ADDENDUM # 2

Bid 17C8, Butterfly Ridge Elementary School – New School Construction
REVISED DUE DATE: January 26, 2017

BUTTERFLY RIDGE ELEMENTARY – NEW SCHOOL CONSTRUCTION

**BUTTERFLY RIDGE ELEMENTARY SCHOOL
BID PACKAGE
ADDENDUM NO. 2
21347.00**

ADD 2
SKA-2.9

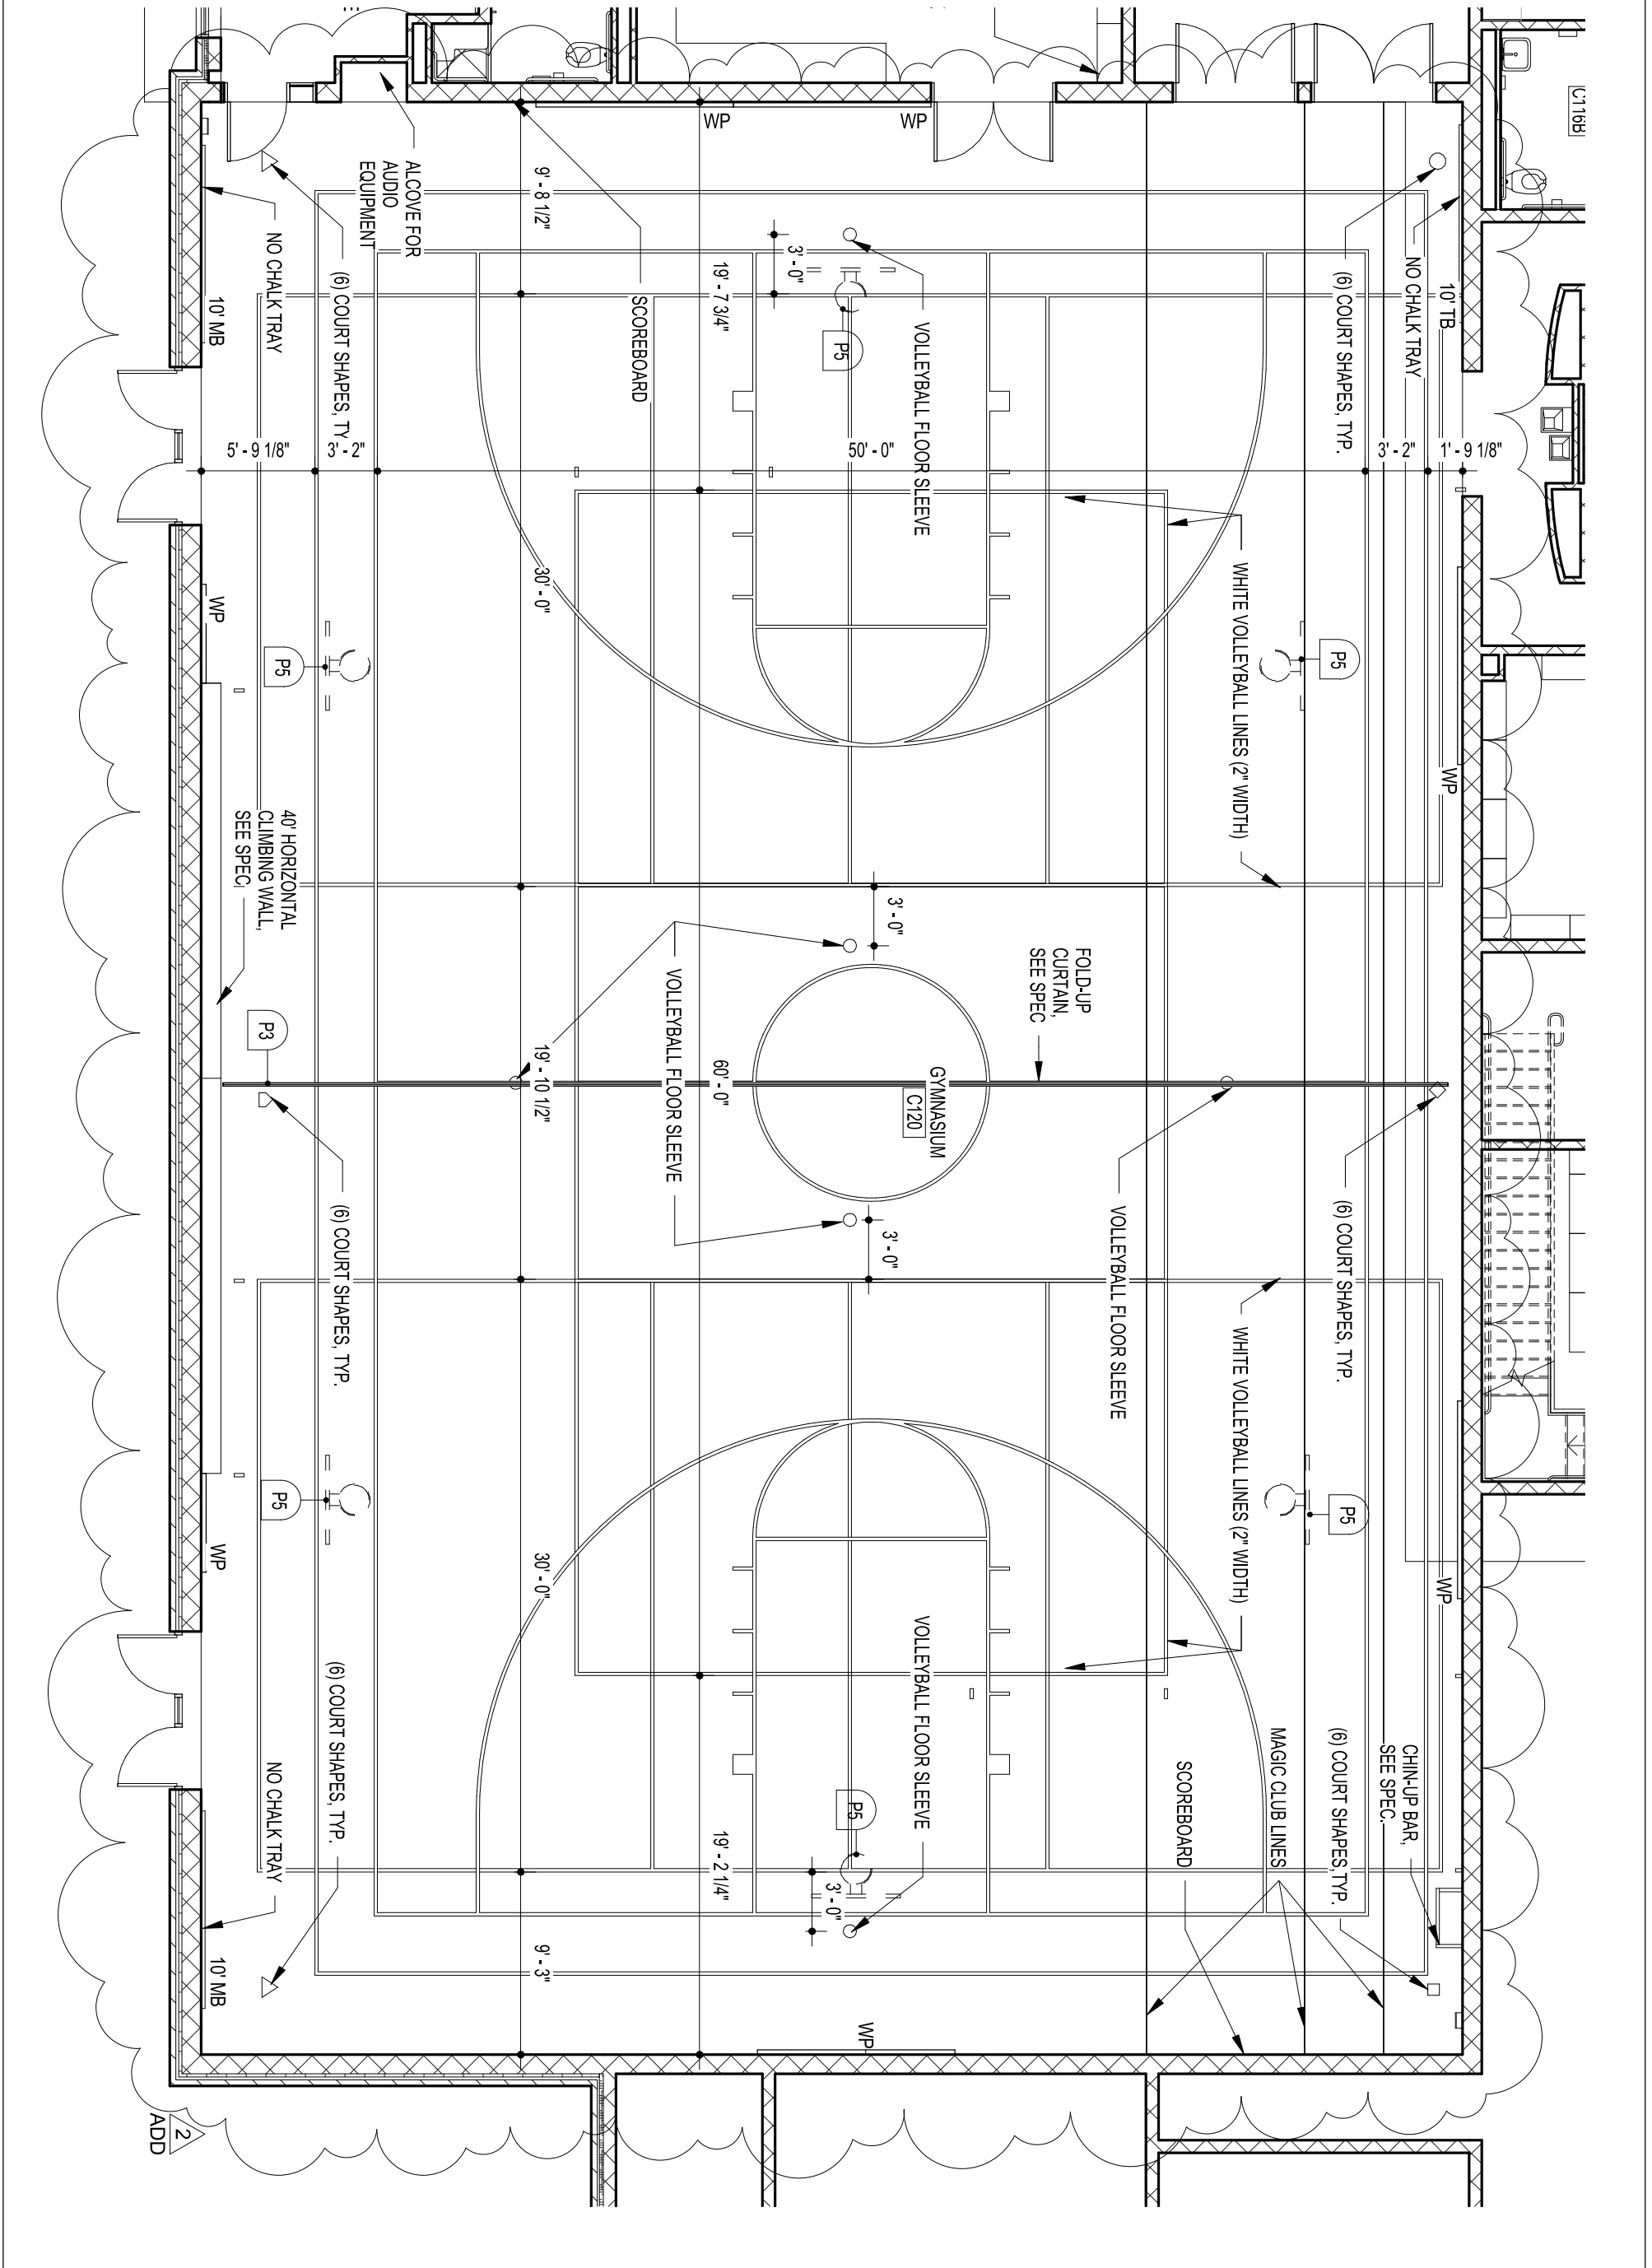
- ITEM NO. A16: SHEET A-7.3 REFLECTED CEILING PLAN-FIRST FLOOR-AREA C1
REVISE Plan A15 per attached sketch SKA-2.9.
- ITEM NO. A17: SHEET A-9.3 PARTIAL FIRST FLOOR FURNISHING PLAN-AREA C1
REVISE Plan A14 per attached sketch SKA-2.10.

ADD 2
SKA-2.11

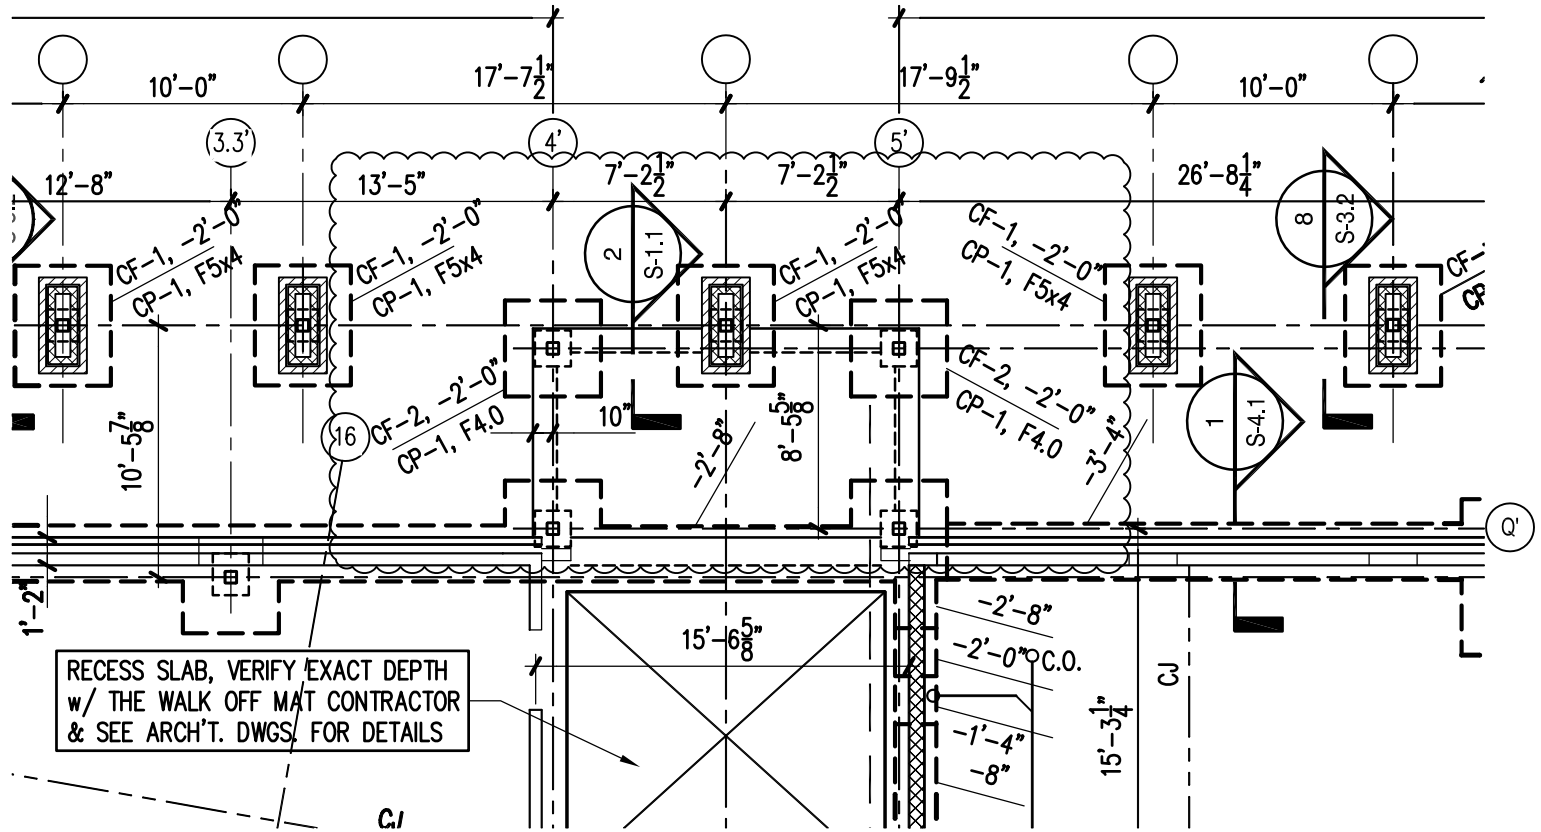
- ITEM NO. A18: SHEET A-9.4 PARTIAL FIRST FLOOR FURNISHING PLAN-AREA C2
REVISE Plan A17 per attached sketch SKA-2.11.

ADD 2
SKS-1

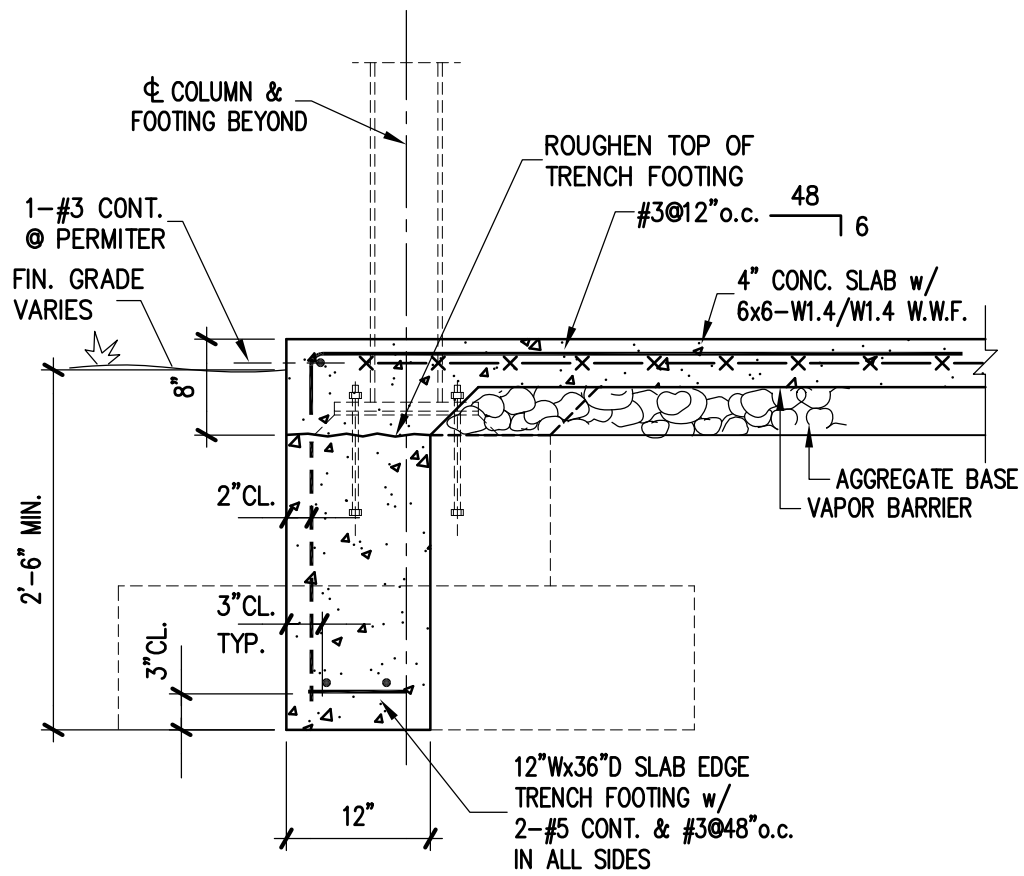
- ITEM NO. S1: SHEET S-1.1 FIRST FLOOR PLAN – AREA A
REVISE Foundation Plan per attached sketch SKS-1.
ADD Detail 2/S-1.1 per attached sketch SKS-1.
- ITEM NO. S2: SHEET S-1.7 SECOND FLOOR PLAN – AREA C1
REVISE Second Floor Framing Plan per attached sketch SKS-2.
- ITEM NO. S3: SHEET S-1.8 SECOND FLOOR PLAN – AREA C2
REVISE Second Floor Framing Plan per attached sketch SKS-3.
ADD Section 5/S-1.8 per attached sketch SKS-5.
- ITEM NO. S4: SHEET S-1.9 ROOF FRAMING PLAN – AREA A
REVISE Roof Framing Plan per attached sketch SKS-4.
- ITEM NO. S5: SHEET S-1.10 ROOF FRAMING PLAN – AREA A & B
REVISE Roof Framing Plan per attached sketch SKS-4.

ADD 2
SKS-5

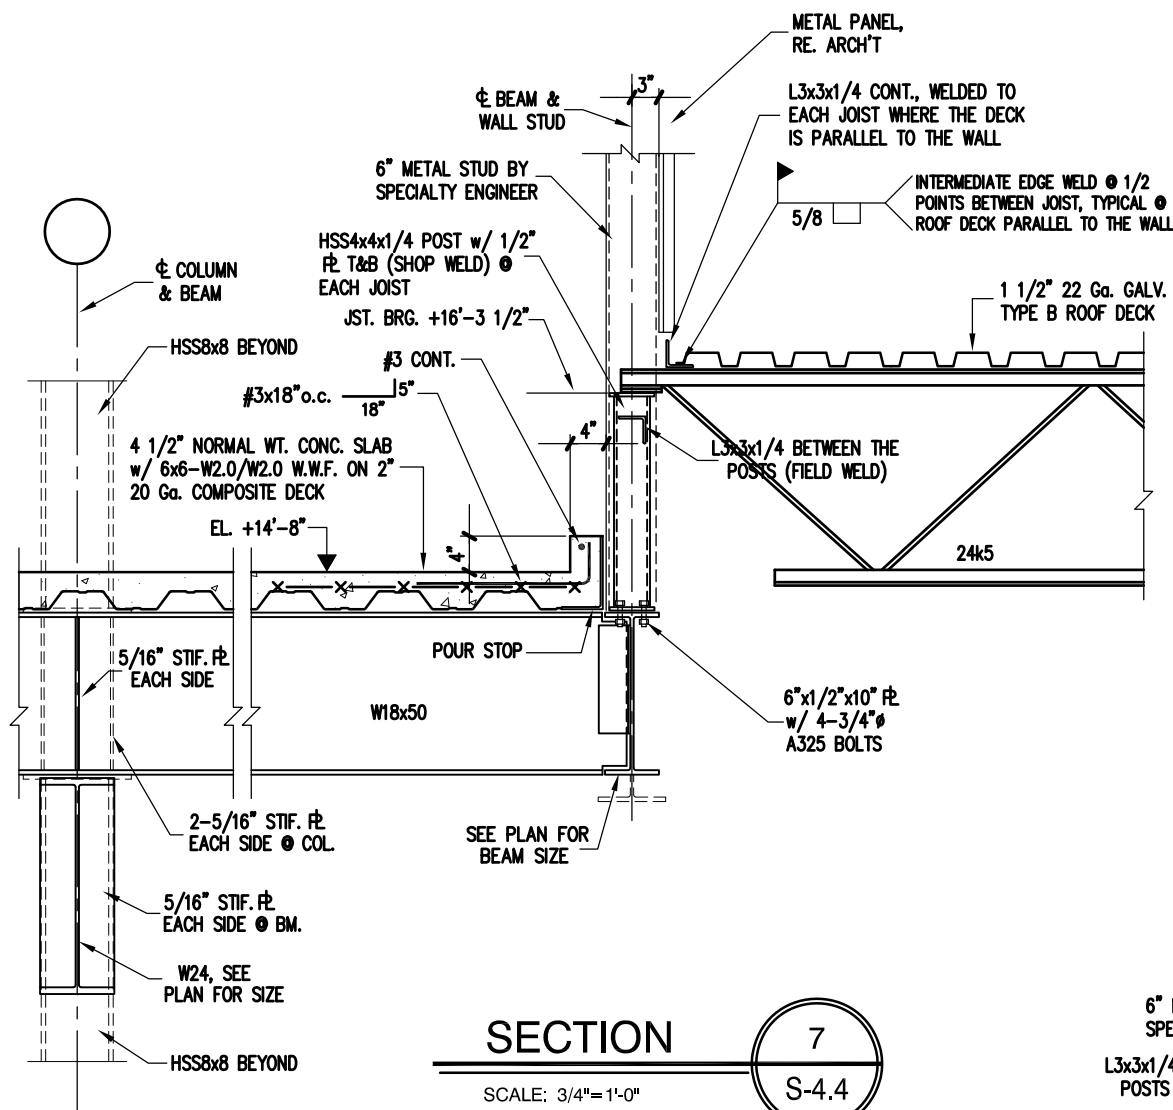
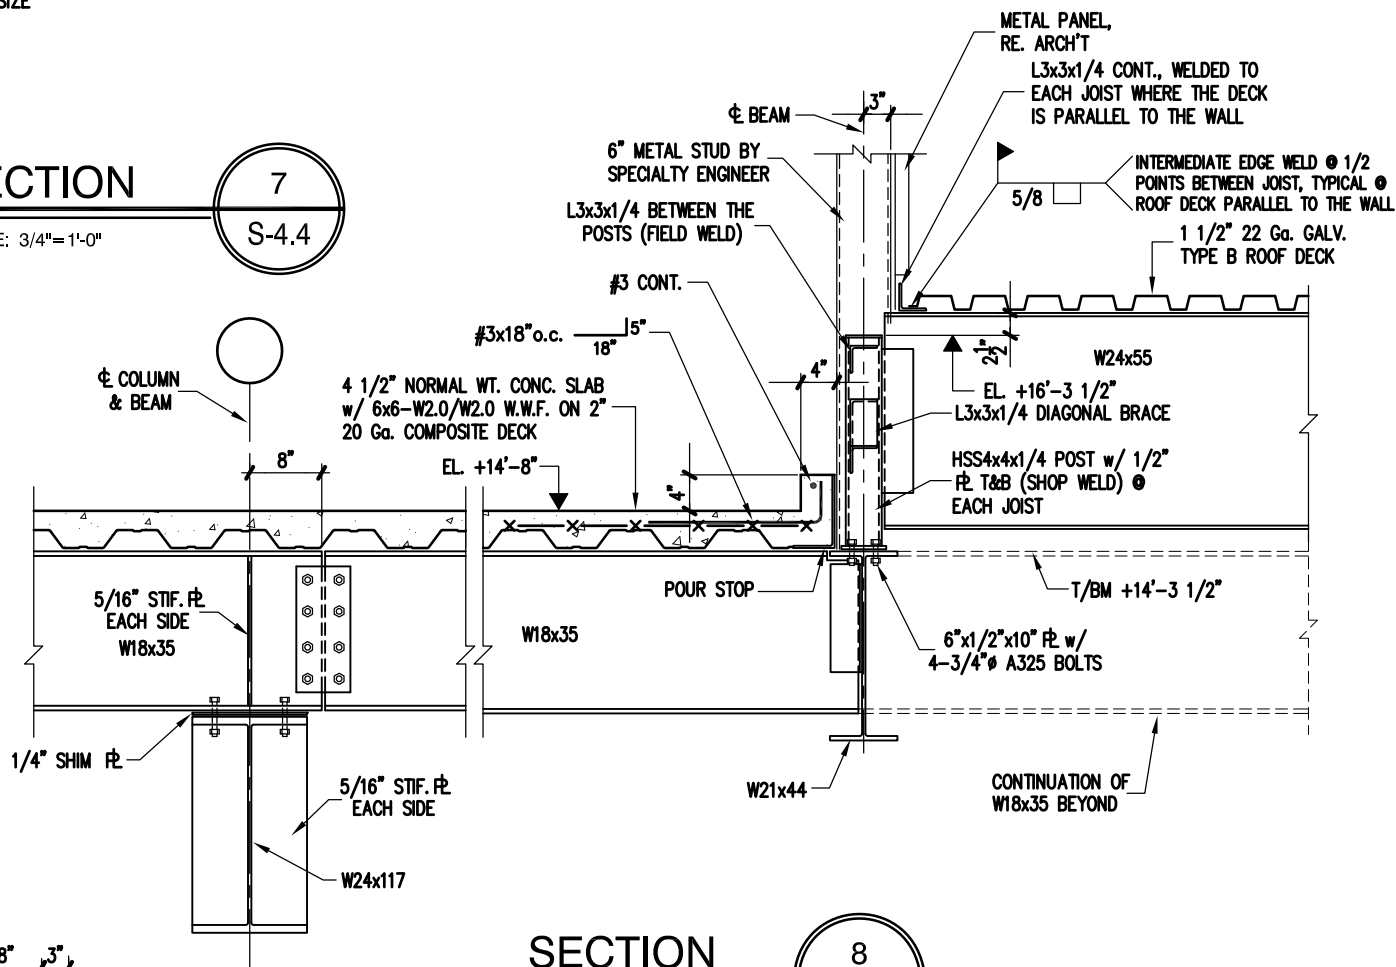
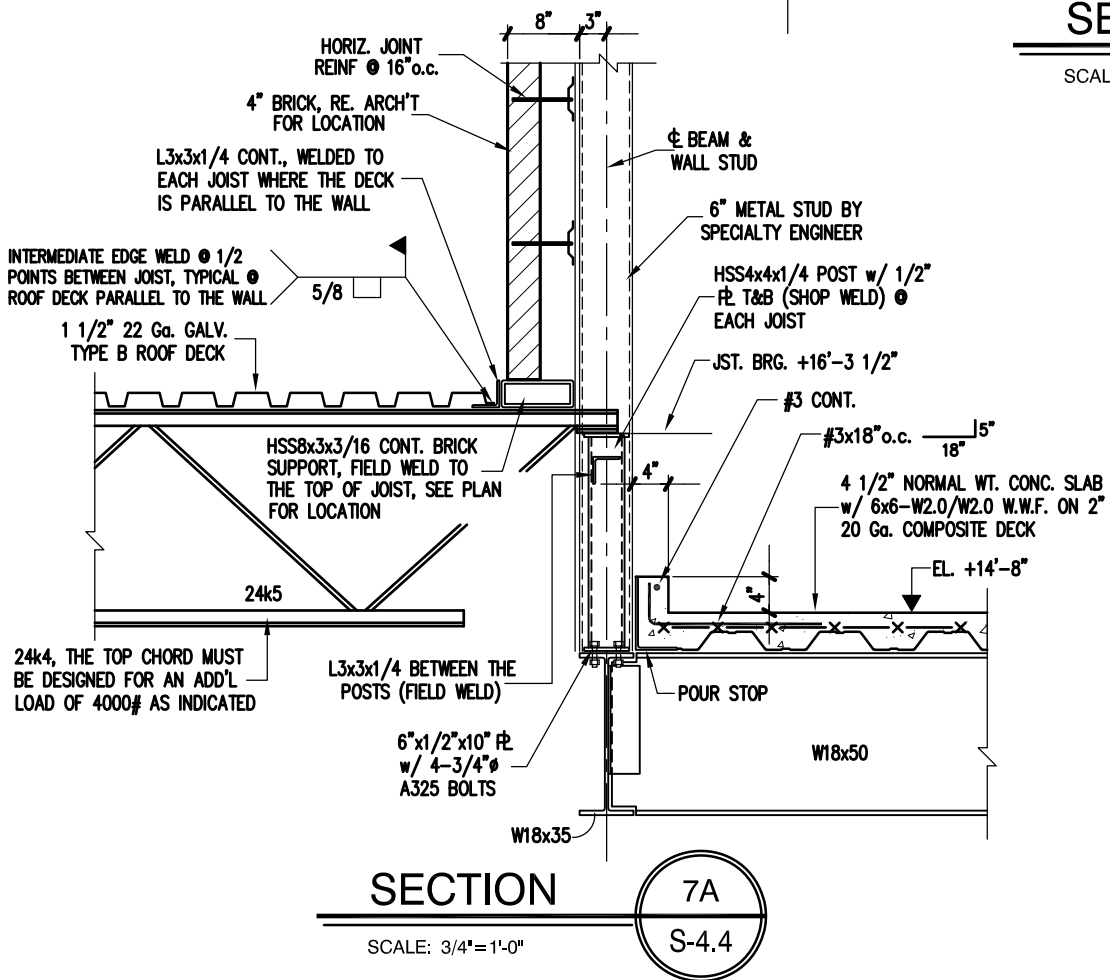
ITEM NO. S6: SHEET S-4.4 SECTIONS
REVISE Sections 7 and 8 per attached sketch SKS-5.
ADD Section 7A per attached sketch SKS-5.
